Mask Set Errata for Mask 3K45H

This mask set errata applies to the mask 3K45H for these products:

- MC68HC908JB8

SE115-Power

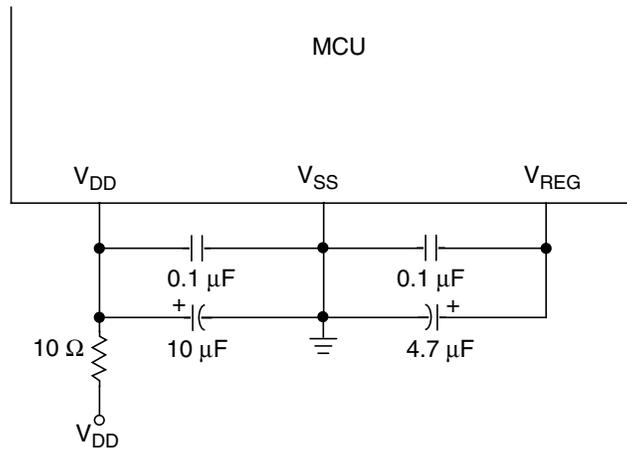
A few devices start abnormally during power-up. The issue is the release of the low voltage reset (LVR) earlier than the V_{REG} reaching the CMOS logic operating voltage (typical 0.65 V).

The LVR takes the V_{DD} but not the V_{REG} as a reference. LVR exists until the V_{DD} reaches the LVR threshold voltage (V_{LVR}). The problem happens in few devices when the V_{DD} rises quickly and the V_{REG} rises slowly. If the LVR has been released but the V_{REG} doesn't reach the CMOS logic operating voltage, the LVR does not have any effect. This might cause the internal logic to improperly initialize and the MCU might not start normally.

Therefore, the V_{DD} voltage must be lower than the VLVR minimum (2.8 V) when the V_{REG} voltage reaches the CMOS logic operating voltage.

To fix the problem, add a 10 Ω series resistor between the power supply and the V_{DD} , and place a 10 μF capacitor at the V_{DD} pin and a 4.7 μF capacitor at the V_{REG} pin.

SE30-PWM

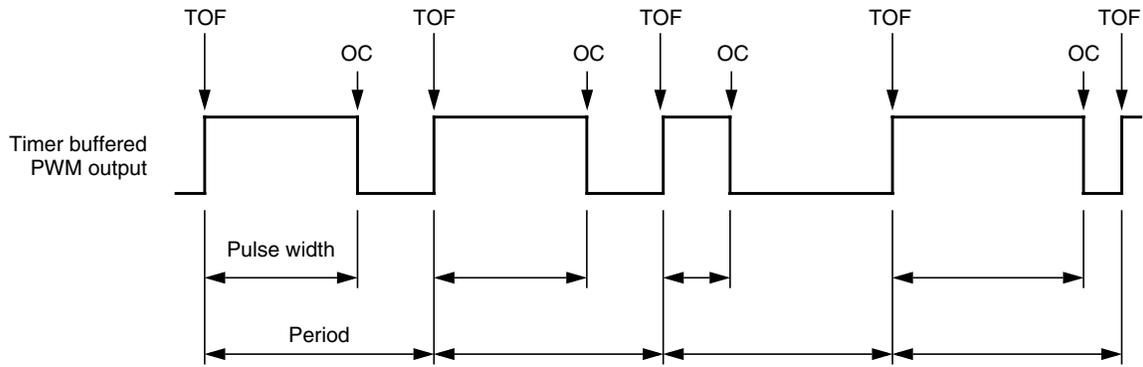
In timer buffered PWM operation, when a timer overflow (TOF) event or an output compare (OC) event coincides with a write to either pair of the timer channel registers (TCHxH/L), the duty cycle at the PWM output glitches to 0% or 100% momentarily, then returns to proper operation.

The figure below shows a typical timer buffered PWM output waveform, indicating the TOF and OC events.

To avoid the glitches when changing the PWM duty cycle, do not write to either pair of the timer channel registers at the TOF or OC.

For example, in the TOF interrupt service routine: If the OC occurs near the last TOF, write to the timer channel registers after the OC; if the OC occurs near the next TOF, write to the timer channel registers before the OC. A write to the channel register high byte (TCHxH) should immediately followed by a write to the low byte (TCHxL) to avoid TOF or OC occurring between the writes. Instruction cycle times must be included when making timing calculations.

Do not write to either pair of timer channel registers at:
 TOF (timer overflow), or
 OC (timer output compare) edges.
